Access Compliance Report

Public Rights-of-Way (Curb Ramps)

Intersection ID: 7014	Main Street: BROOKWOOD_RD	Cross Street: BLAZE_MANOR_LN	Location: NW
ADA ID: F451BB58F1A0	Ramp Type: PerpDiag	Initial Pass/Fail: Fail	Overall Compliance: No
Severity Score: 8.75			
Codes/Mitigation Info/Possible Solution		Field Measurements/Component Compliance

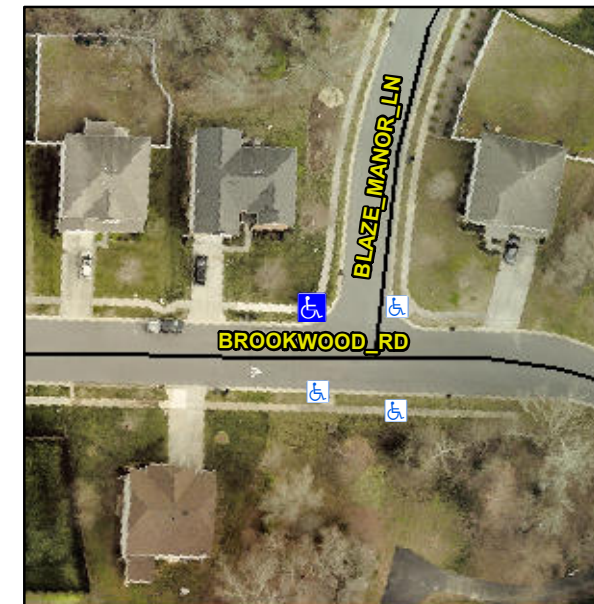
Not Found, R304.5.1

Compliance	Description	Data	Compliance	Description	Data
N/A	Ramp Length (in)	72.0	Yes	Ramp Slope (%)	8.1
No	Ramp Width (in)	46.0	Yes	Ramp XSlope (%)	0.2
N/A	Flare Type LT	N/A	N/A	Flare Type RT	N/A
N/A	Flare Slope LT (%)	N/A	N/A	Flare Slope RT (%)	N/A
N/A	Flare Traversable LT?	N/A	N/A	Flare Traversable RT?	N/A
N/A	Landing Length (in)	N/A	N/A	DWS Provided?	N/A
N/A	Landing Width (in)	N/A	N/A	DWS Contrast?	N/A
N/A	Landing Slope (%)	N/A	N/A	DWS Length (in)	N/A
N/A	Landing X Slope (%)	N/A	N/A	DWS Full Width?	N/A
N/A	Landing Curb? (Y/N)	N/A	N/A	DWS Offset (in)	N/A
N/A	Shared Landing?	N/A			
N/A	Gutter Ponding?	N/A	N/A	Gutter Slope (%)	N/A
N/A	Gutter Lip Ht (in)	N/A	N/A	Gutter X Slope (%)	N/A
N/A	Painted X Walk1?	No	N/A	Painted X Walk2?	No
	X Walk 1 Direction	To S		X Walk 2 Direction	To E
N/A	X Walk 1 Width (in)	N/A	N/A	X Walk 2 Width (in)	N/A
	X Walk 1 Slope (%)	4.6		X Walk 2 Slope (%)	3.6
	X Walk 1 X Slope (%)	2.6		X Walk 2 X Slope (%)	3.2

Remove & Replace Curb Ramp With Two New Directional Ramps or Equivalent.
